Subject: CUP Application for Metro Transit Park and Ride at  
I-94 and Manning Avenue  
Lot 1, Block 1 of Four Corners 2<sup>nd</sup> Addition to the City of Lake Elmo

Re: Metro Transit Park & Ride at I94 and CSAH-15  
Engineering Plan Review

**To:** Ken Roberts, City of Lake Elmo Planning Director  
**From:** Lucius Jonett, Wenck Landscape Architect  
**Date:** March 29, 2019  
**Subject:** City of Lake Elmo Landscape Plan Review  
Metro Transit Park and Ride, Review #1

I-94 AND MANNING AVENUE PARK AND RIDE STATION  
11530 HUDSON BOULEVARD NORTH  
GRADING, DRAINAGE & EROSION CONTROL PLAN  
LAKE ELMO, MINNESOTA 55042

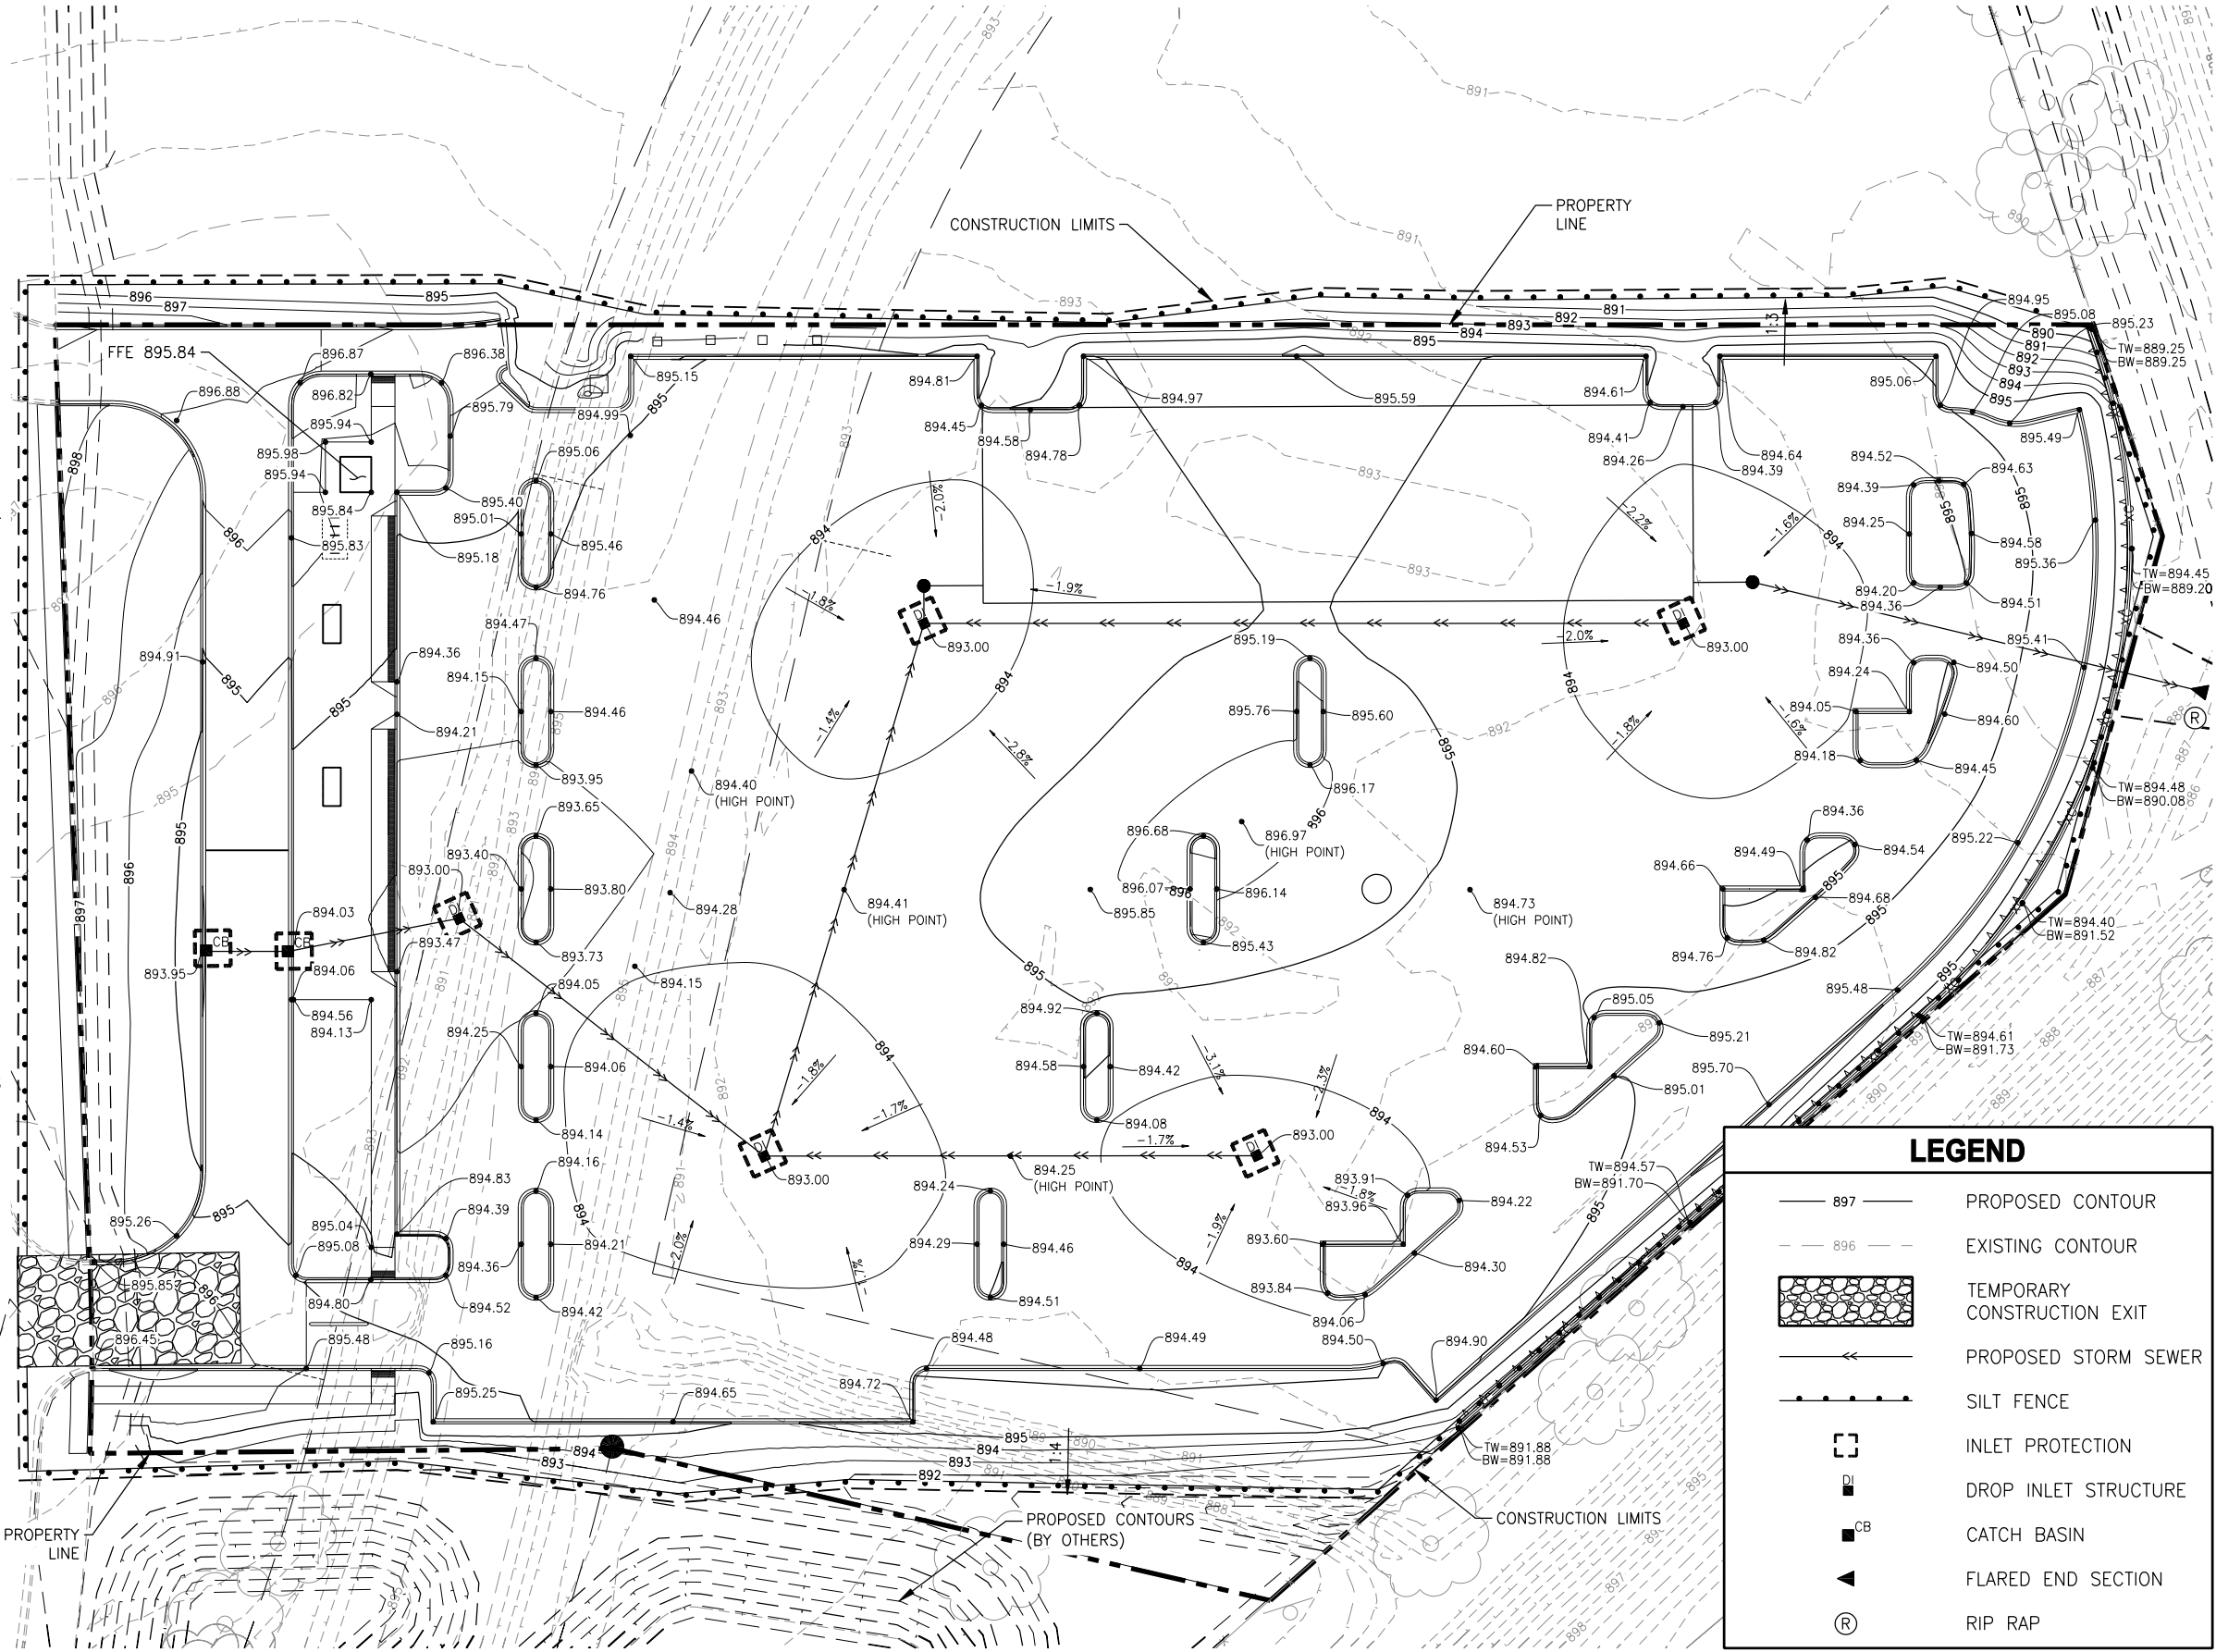
- C3.0. Grading, Drainage and Erosion Control. Revise the erosion control plans to include the City of Lake Elmo standard plan notes for erosion control and City standard details for erosion control. The specifications must be updated to include the City of Lake Elmo standard specifications for erosion control. The City specifications, details and plan notes must be identified to supersede all other plans and specifications in case of conflict.

- C3.0. Grading, Drainage and Erosion Control. Revise plans to identify Hudson Boulevard as "proposed" and to be constructed "by others". Add plan note that grading revisions may be required to match into the final constructed grades for Hudson Boulevard.

- C3.0. Grading, Drainage and Erosion Control. Add erosion control and restoration measures at the storm sewer outfall pipe off-site.
- C4.0. Utility Plan. Revise the utility plans to show the sewer and water service connections to be located at the right-of-way of Hudson Boulevard. The public improvement project must be updated to provide sewer and water service stubs from the mains to the right-of-way consistent with City of Lake Elmo standard service details.

I-94 AND MANNING AVENUE PARK AND RIDE STATION  
11530 HUDSON BOULEVARD NORTH  
UTILITY PLAN  
LAKE ELMO, MINNESOTA 55042

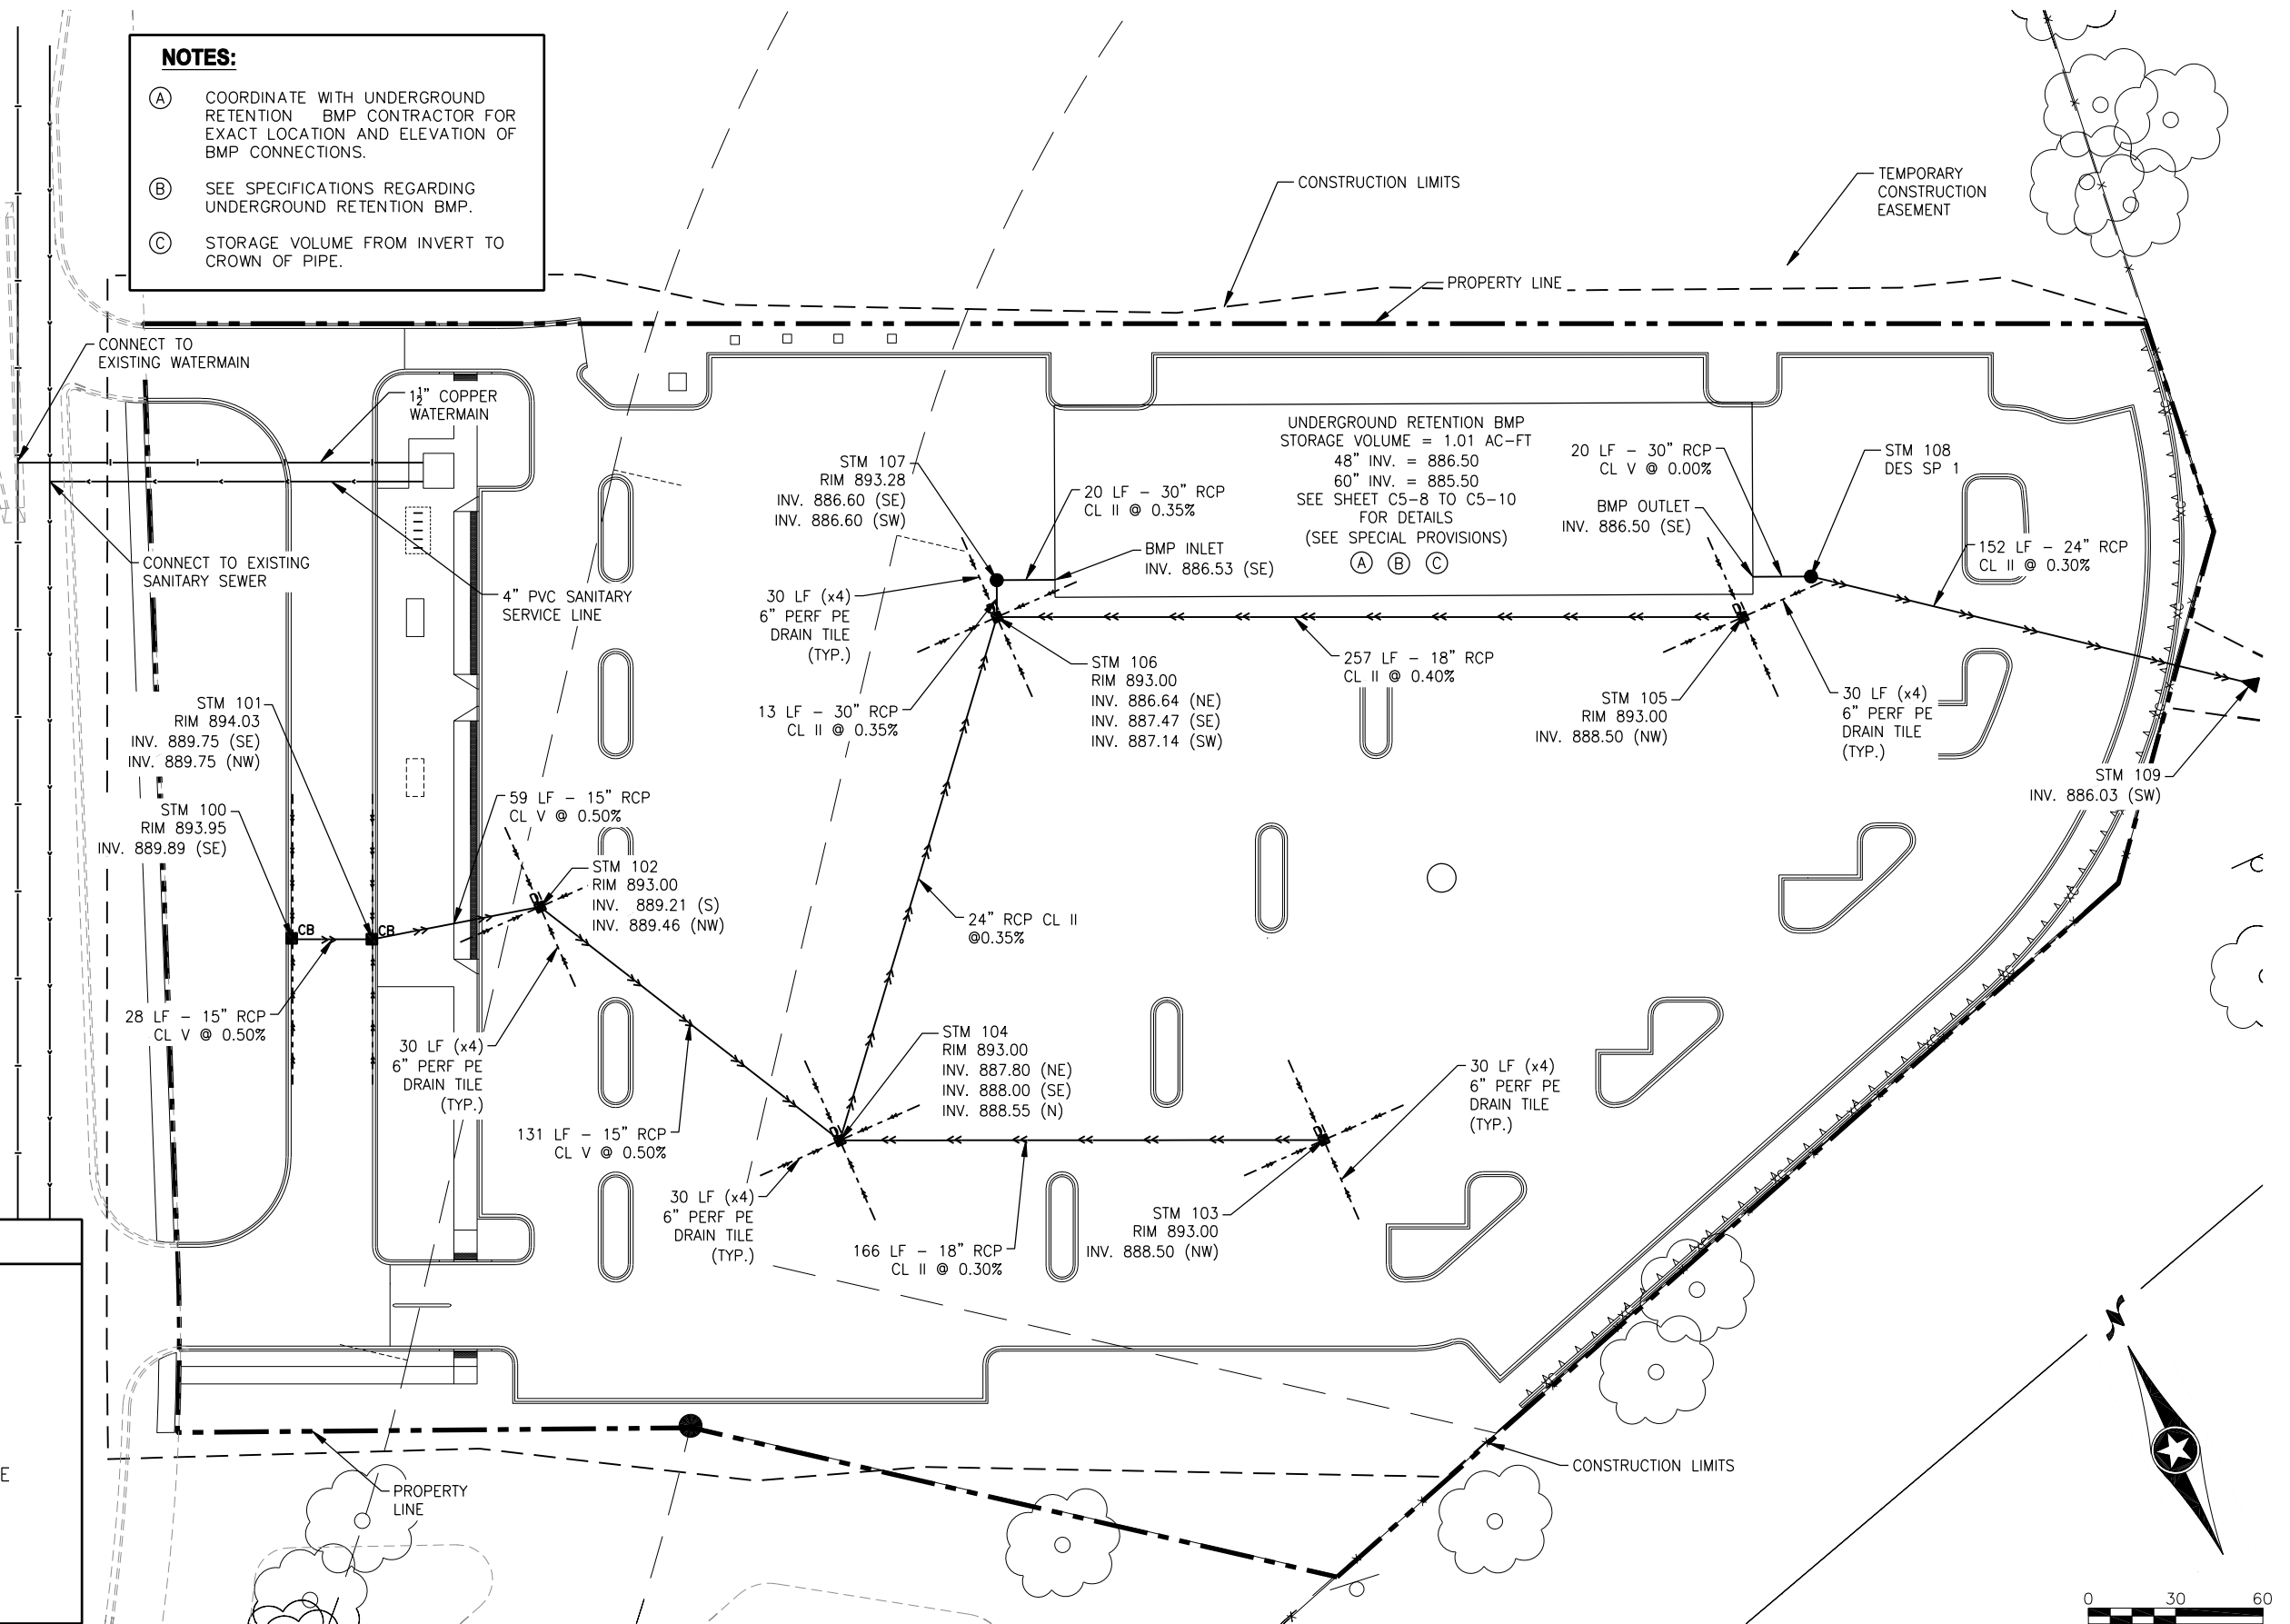
- C4.0. Revise the utilities shown in Hudson Boulevard from "existing" to "installed by others".
- C4.0. Utility Plan. Add hydrants interior to the site as required by the Lake Elmo Fire Department. See attached plans showing required locations.

- C4.0. Utility Plan. Revise plans to extend 8-inch watermain interior to site to each hydrant and create a looped main configuration. Update the plans to show a minimum 30-foot utility easement centered over all watermain and hydrants. Easement must extend minimum 15-feet from all pipe and hydrants.

- C4.0. Utility Plan. Revise the utility plans to include the City of Lake Elmo standard plan notes for watermain and City standard details for watermain. The specifications must be updated to include the City of Lake Elmo standard specifications for watermain. The City specifications, details and plan notes must be identified to supersede all other plans and specifications in case of conflict.
